CHAPTER-4

PROJECT MONITORING

4.2 Audit along with Technical Consultant (IIT Delhi) reviewed the quality controls measures in DMRC and observed the following:

Figure-4.1

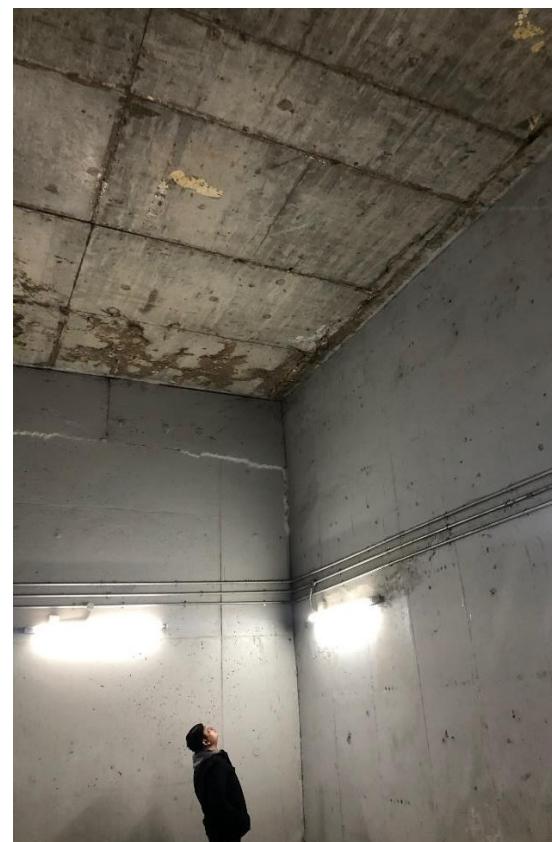
Review of the design and drawings of station buildings, viaducts and tunnels revealed that optimisation of quantities was not attempted and there was overdesigning. Further, Technical Consultant (IIT Delhi) observed instances of honeycombing and bulged concrete, in Malviya Nagar, Najafgarh, Hauz Khas, Kalkaji metro stations etc., as indicated in figures below:

Honeycombing and bulged concrete surface

Honeycombing and poorly made formwork joints

The Ministry/ GNCTD/ DMRC has accepted the observation.
